Amendments to the Drawings:

REMARKS/ARGUMENTS

FIG. 5

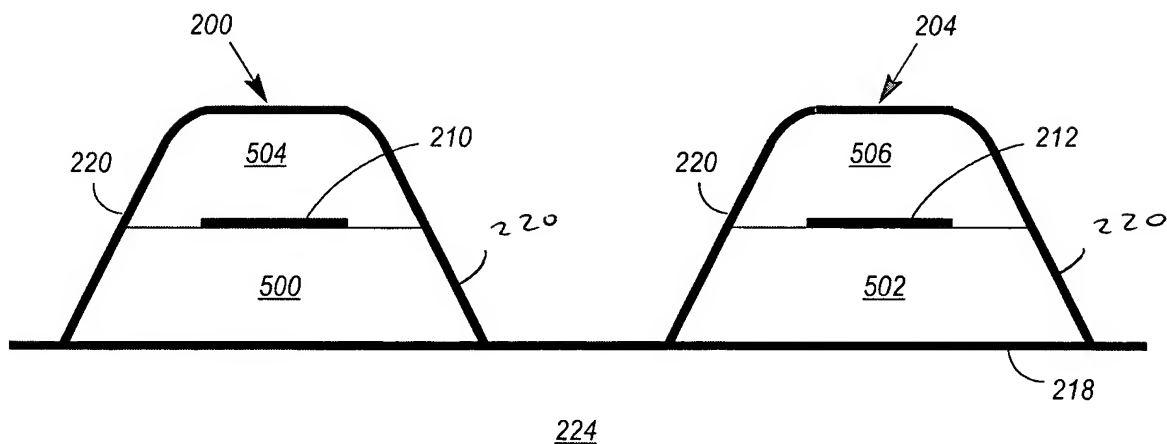
The Examiner objects to FIGS. 5 & 6 of the drawings because reference number "220" does not appear on the right-hand sides of the ground shields 220. Applicants have amended the drawings to include these additional references to ground shields 220. Applicants do not believe their amendments add new matter.

The attached sheet of drawings includes changes to FIGS. 5 & 6. This sheet, which includes FIGS. 5 & 6, replaces the original sheet including FIGS. 5 & 6. In each of FIGS. 5 & 6, the reference number "220" has been repeated in additional places to more clearly indicate the extent of the "ground shield 220" in each figure.
